City of Detroit

CITY PLANNING COMMISSION
208 Coleman A. Young Municipal Center
Detroit, Michigan 48226
Phone: (313) 224-6225 Fax: (313) 224-4336
e-mail: cpc@detroitmi.gov

RE: Request of SDG Associates, LLC on behalf of the Detroit Regional Convention Facility Authority for PC/PCA (Public Center/Public Center Adjacent) Special District Review of proposed signs and trash compactor enclosure at the TCF Center at 1 Washington Boulevard (formerly Cobo Center). **(RECOMMEND APPROVAL)**

DATE: May 18, 2020

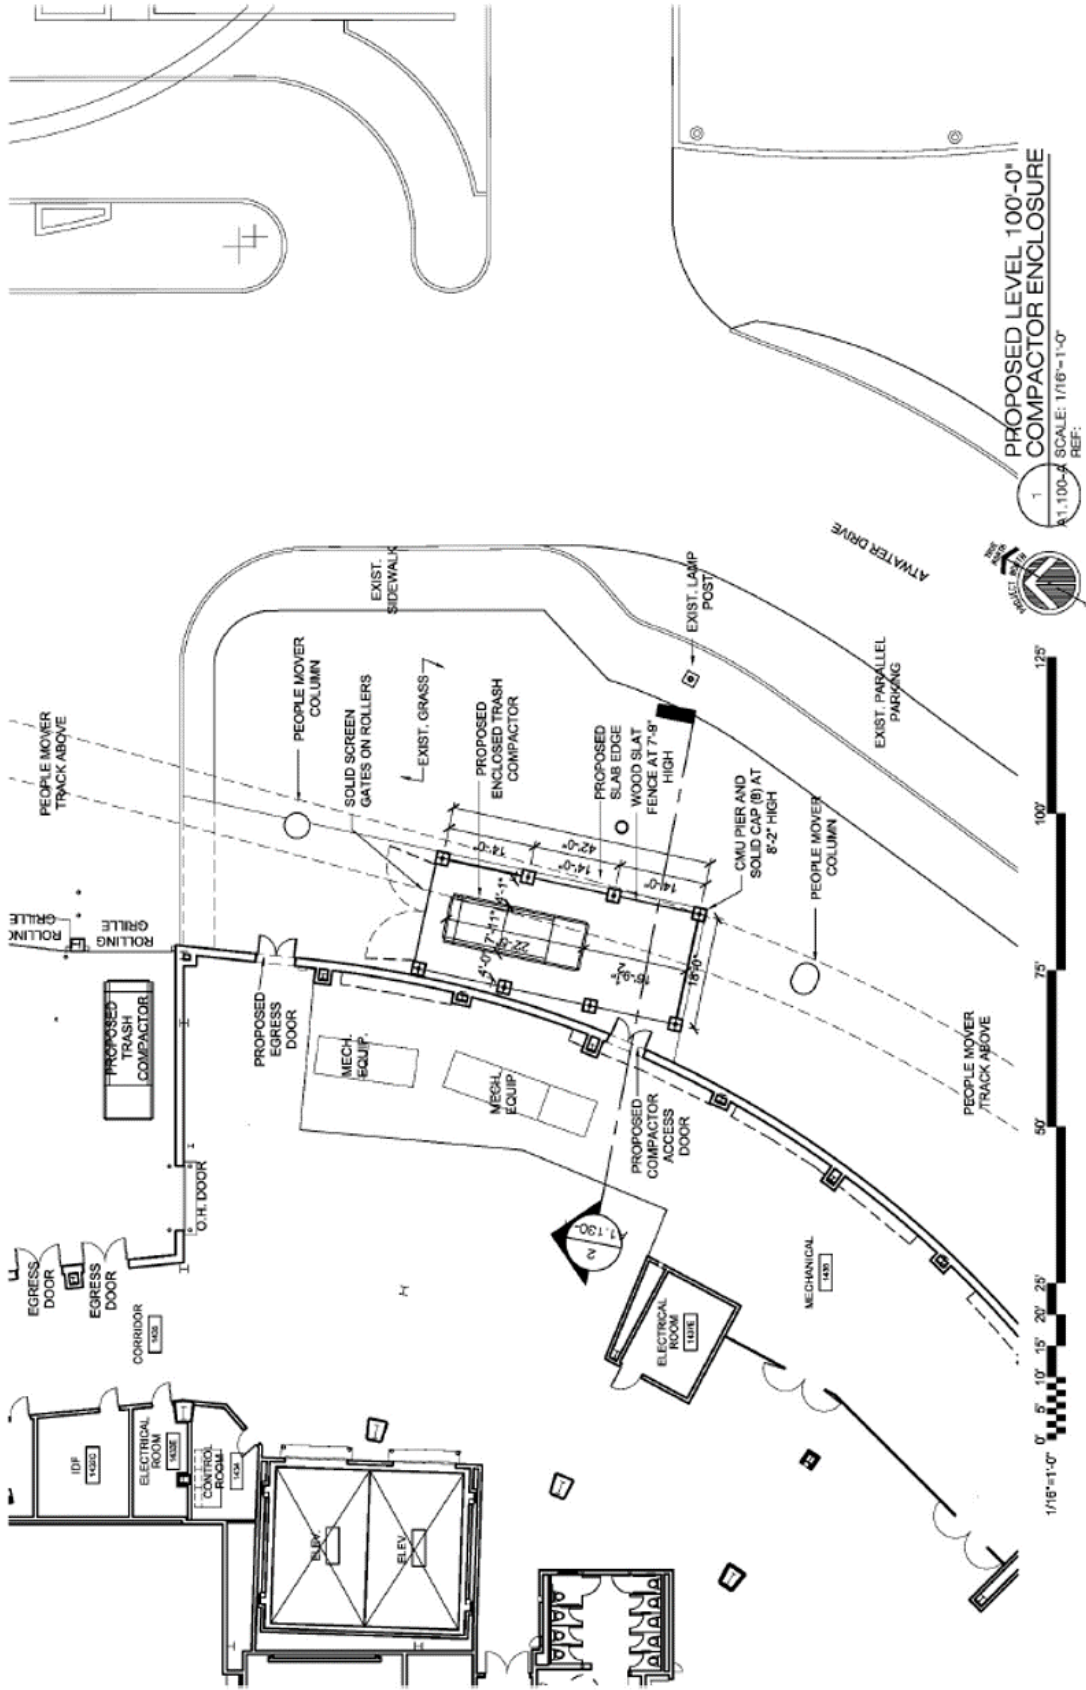
As a result of the rebranding of Cobo Center as TCF Center, a number of changes to signage and installation of new signs are proposed. Details of all changes to signage on and around the Center are included in the submission package; but this report will focus on exterior identification signs as the interior signage does not require PC/PCA review and the wayfinding changes are relatively minor. New exterior identification signs are proposed in four locations (illustrations of the proposed signs are included on the last pages of this report):

- Three signs are proposed above the entrances on the eastern façade of the building where the large red COBO signs were previously located. The old signs were 520 square feet each and the proposed signs are 785 square feet each.
- One sign is proposed on the roof of the ballroom (formerly Cobo Arena) and will not be visible from the ground. As this sign will not be visible from a public right-of-way, it is not evaluated as a sign.
- At the northeast entrance to the building near the intersection of Washington Boulevard and Congress Street, three options are being considered, either above or below the animated display. Option 2 with the sign attached to the wall near the roofline is preferred. This sign is proposed to be 900 square feet.

- Three signs are proposed on the ballroom near the roofline, one each facing north, south and east. These signs are each proposed to be 785 square feet. No signage has existed in this location before.

Based on the size of this building, 5,972 square feet of signage would be allowed if not for the 500 square foot maximum (This measurement accounts for the east, north and ballroom frontages only, not giving credit for the west or south/river frontages). The proposed exterior identification signs itemized above total 5,611 square feet. For developments that require City Council approval, the 500 square foot maximum may be waived per Section 4-4-7(a). In this case, because the building is very large and not all of the signs will be visible from one vantage point, the additional area is justifiable. Because the building serves as a regional convention center, adequate signage is also important for wayfinding.

As a regional convention center, TCF Center is a destination for many people who may be unfamiliar with the area. Appropriate signage is necessary to identify the building and assist the public in navigating. Although several of the signs are rather large, due to the size of the building and the nature of the use, the additional proposed signage is reasonable.

**PROPOSED ELEVATION
COMPACTOR ENCLOSURE**

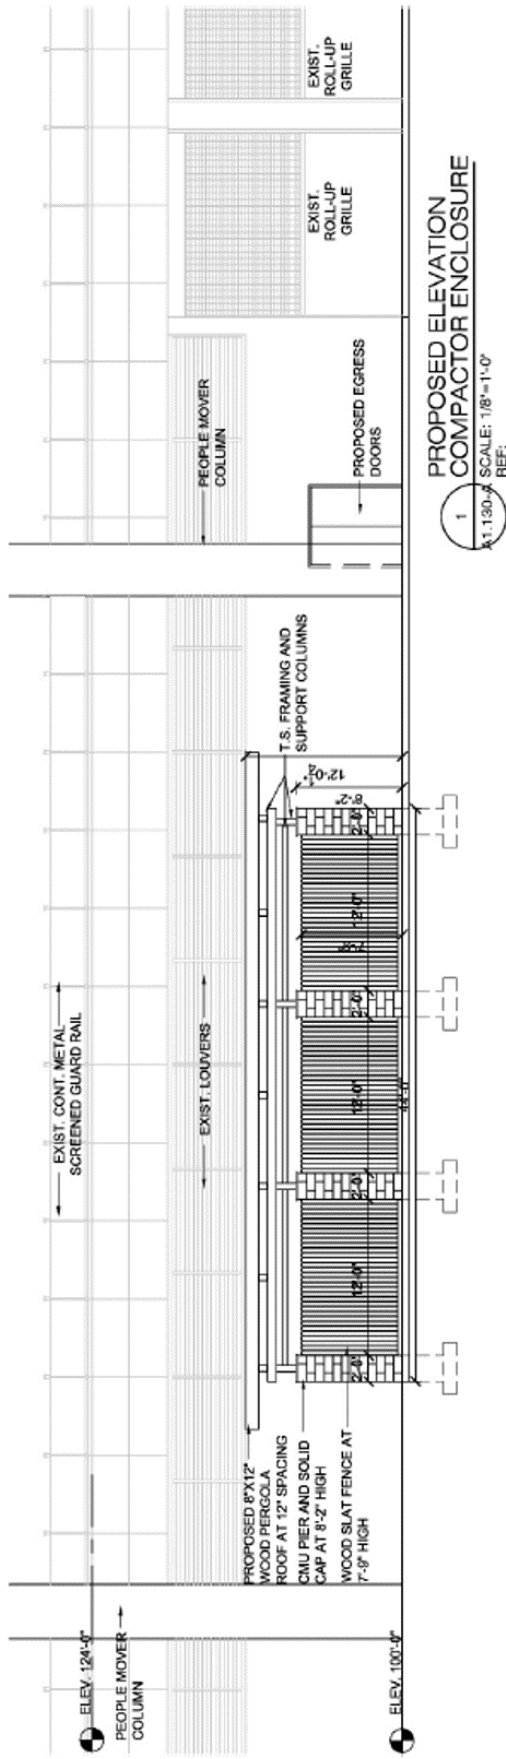
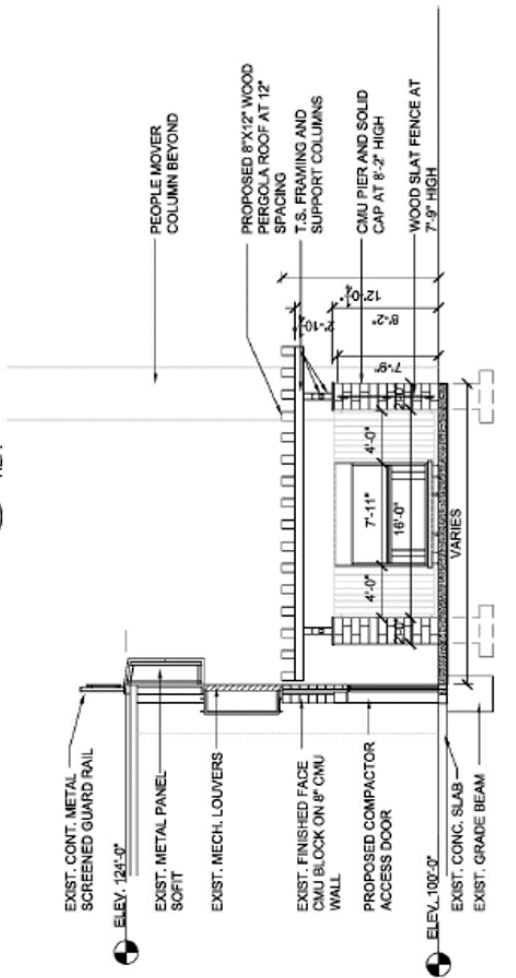
Previously, all of the trash dumpsters have been located in the loading dock area where they are not visible. However, in an effort to divert food waste bound for the landfill, a dumpster specially designed for composting was installed. It is required to be located in a sealed, temperature controlled area to minimize odors which has resulted in a loss of space in the loading dock area. As a result, a compactor needs to be located outside the loading dock area near Atwater Street. A screen wall is proposed to conceal the compactor from ground level and a pergola will screen the view from above.

The proposed screening for the exterior trash compactor is tasteful and the materials complement the surrounding area. The inclusion of a pergola to screen the view from above is especially commendable and shows the utmost level of attention that went into the design.
